## *Device Errata*

# **MPC801**

**Silicon Revision A.2 - Mask Set F87S**  
**May 18, 1998 (Version - 4)**

#### **G5. Potential problems caused by skew between EXTCLK and CLKOUT.**

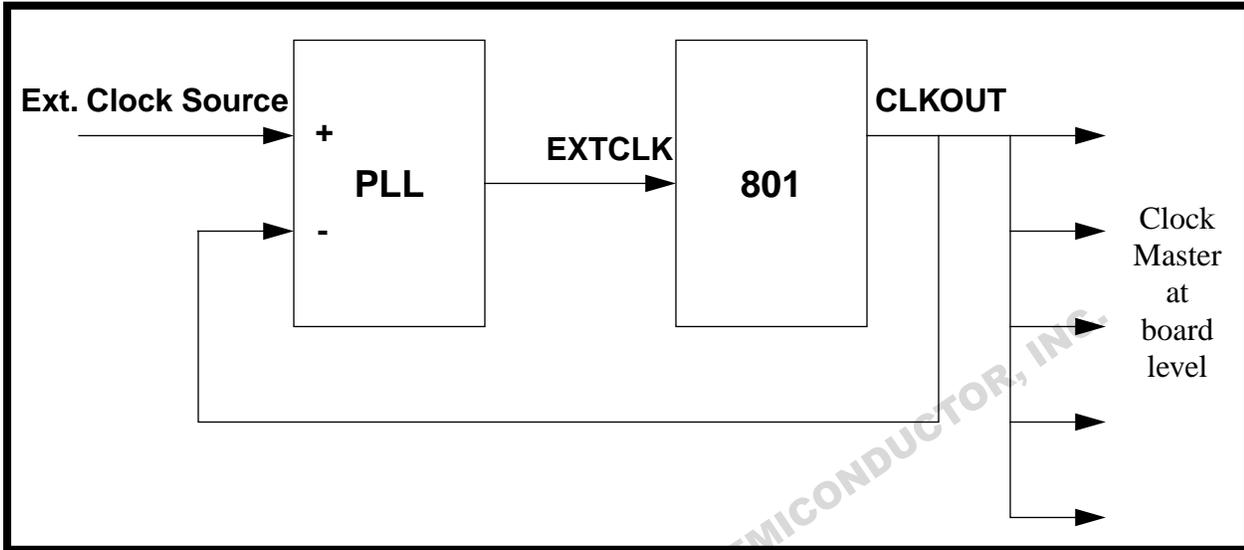
The PLL of the MPC801 locks on the falling edge of the input clock EXTCLK. This will affect the skew between EXTCLK and CLKOUT at the rising edge. The skew is dependent on the duty cycle of the input clock (but for a 50% duty cycle will not exceed 2nS). This will affect synchronous designs where the same clock source is used as an input to EXTCLK, as well as to an external synchronous device (e.g. a peripheral or ASIC).

Case 2. Where it is necessary to synchronize an external master clock (e.g. from a backplane), an MPC801, and external peripherals, to allow data transfers in all three directions:

Insert a PLL between the external master clock and the EXTCLK pin of the MPC801. Connect the phase comparison pin of the PLL to the CLKOUT pin of the MPC 801. Also use the CLKOUT signal as the reference clock for distribution to the local external peripherals.

**Important Note:** The PLL has to be capable of operating with a permanent offset of -2nS, therefore the range of lock should extend to about -4nS.

This will be fixed in future revision, changing the PLL to lock on the rising edge of EXTCLK.
